# COMMITTEE OF ADJUSTMENT

## MINOR VARIANCE REPORT

APPLICATION: **CAV A/160/2022**

| Owner (s)   | Agent  | Location of Land                   |
|---|--|------------------------------------|
| RANDI MILANI<br>CAMILLO MILANI<br>63 VERONICA DR<br>MISSISSAUGA ON, L5G 2B1 | PAUL DEMCZAK<br>BATORY MANAGEMENT<br>655 ANNLAND ST<br>PICKERING ON, L1W 1A9 | 1538 BAYVIEW RD<br>PLAN 358 LOT 26 |

#### **Excerpt of Site Plan by the applicant:**

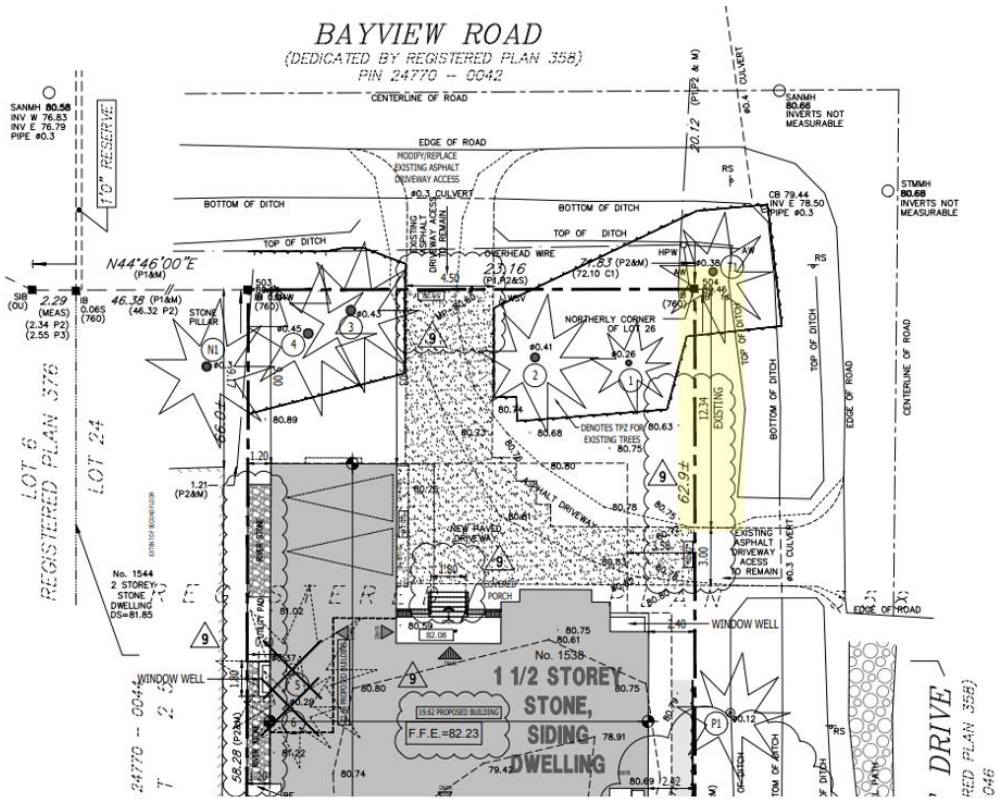
As per the above information there is a discrepancy between the variance application which mentions 12.39 m for the driveway location while the site plan drawing mentions 12.34m away from the point of intersection, which needs to be corrected.

Notwithstanding the comments above, it appears that the applicant has missed a variance for the driveway access off the Bayview (front lot line) which does not meet the minimum requirement of 11.2 m from the interior side lot line whereas the driveway is located at 12.1m from the interior side lot line which is 0.9 m away from the permitted therefore the proposal may not comply with the Zoning By-law requirements.

Therefore, depending on the outcome of this application, the applicant may need to revise the proposal to comply with relevant regulations during construction, which may or may not be in general accordance with the plans submitted with this application. Staff are recommending that the plans be to the satisfaction of the Director of Planning since it appears that many of the deficiencies can be resolved with slight updates to the plans.

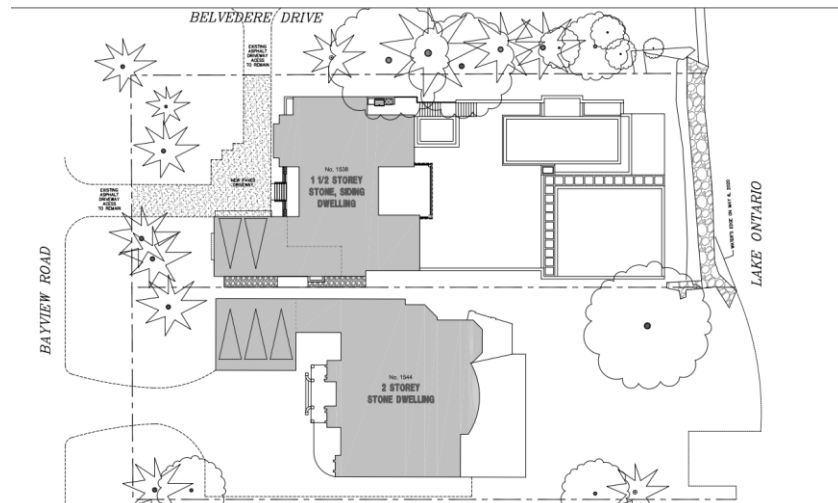
The applicant requests relief from Zoning By-law 2014-014, as amended, to increase the garage projection from 1.5 metres to 9.29 metres from the face of the longest portion of the main wall. The intent of regulating the garage projection is to prevent the garage from being a visually dominant feature of the dwelling. In this instance, the subject property is a corner lot located at the intersection of Bayview Road and Belvedere Drive, characterized by projecting garages which is a common character in the neighbourhood which makes the proposed design compatible with the streetscape. An example of a similar design with projecting garage feature present in the adjacent dwelling has been provided in the figure below. The design elements incorporated in the proposed design with covered porches, setbacks and one-storey elements helps to break up the massing of the dwelling and softens the impact of the garage projection. Staff are of the opinion that the requested projection is compatible with the neighbourhood character and is appropriate in this context which meets the intent of the Zoning By-law. Excerpt of the Site Plan in comparison with the adjacent dwelling by the applicant

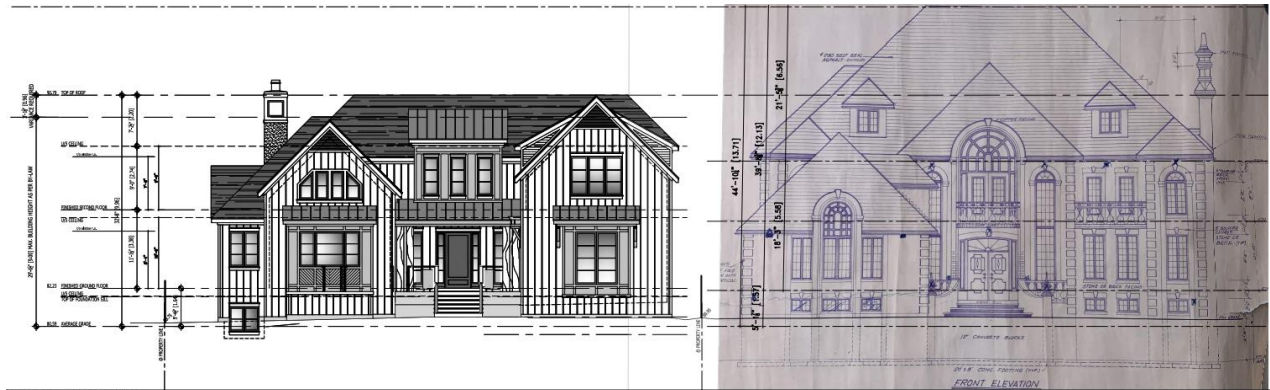
The applicant is requesting relief from Zoning By-law 2014-014, as amended, to permit a decrease in minimum front yard setback from 14.96 metres to 9.0 metres. The front yard is measured from the front property line to the main wall. The intent of regulating the front yard setback is to ensure a relatively uniform setback along the street. In this instance, the existing dwelling was set back further than the adjacent dwellings. The revised setback will result in a more uniform setback with projecting garage inline with the similar projection to the adjacent dwelling. Staff are of the opinion that the decrease in front yard setback will not have a negative impact on adjacent and surrounding properties, is desirable for the development of the property and meets the intent of the Official Plan and Zoning By-law.
